**Appendix A**  
**Wetlands and Waterways**

**A-2 U.S. Army Corps of Engineers,  
Preliminary Jurisdictional Determination, June 2011**

SUBJECT: Preliminary Jurisdictional Determination for Department of the Army Application  
No. 2008-01754

**WETLANDS & WATERWAYS  
DELINEATION REPORT**

WETLAND  
DELINEATION  
PLAN

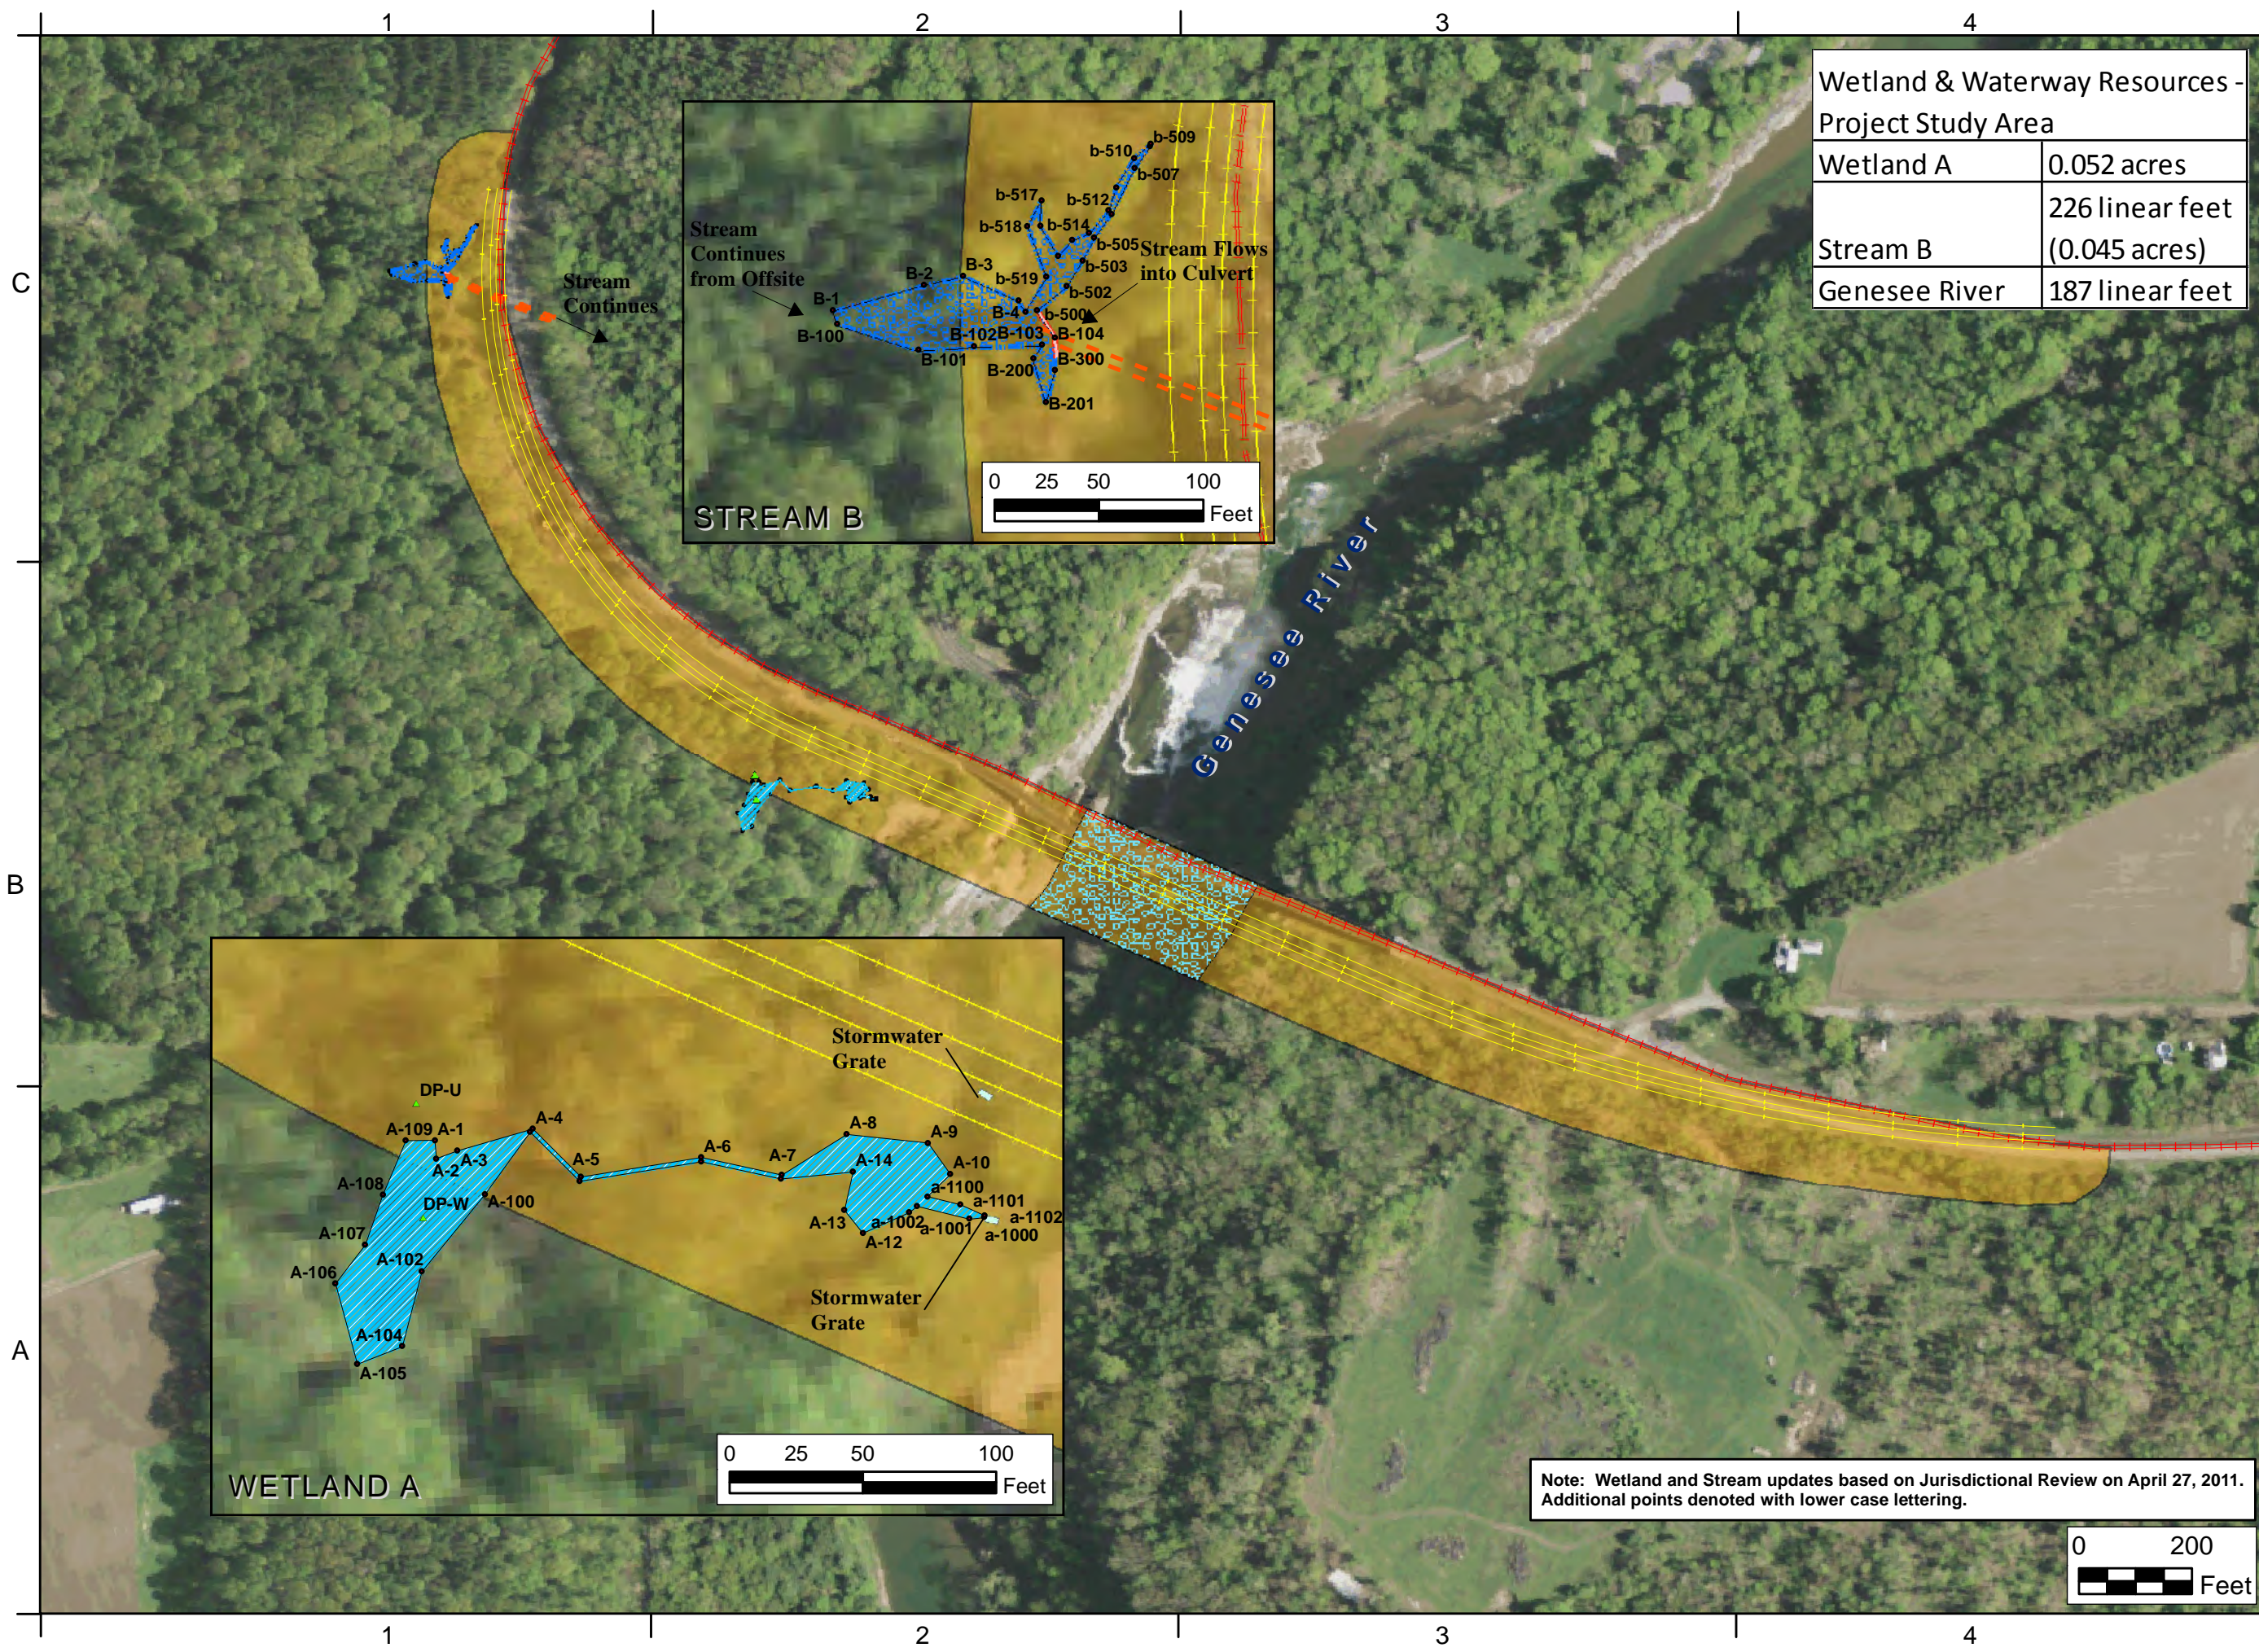
I have evaluated your submitted wetland delineation map and have determined that the wetland and water boundaries shown on the map accurately represent on-site conditions. I have enclosed the Preliminary JD Form with this letter. The form and attached table identifies the extent of waters on the site and specific terms and conditions of the Preliminary JD.
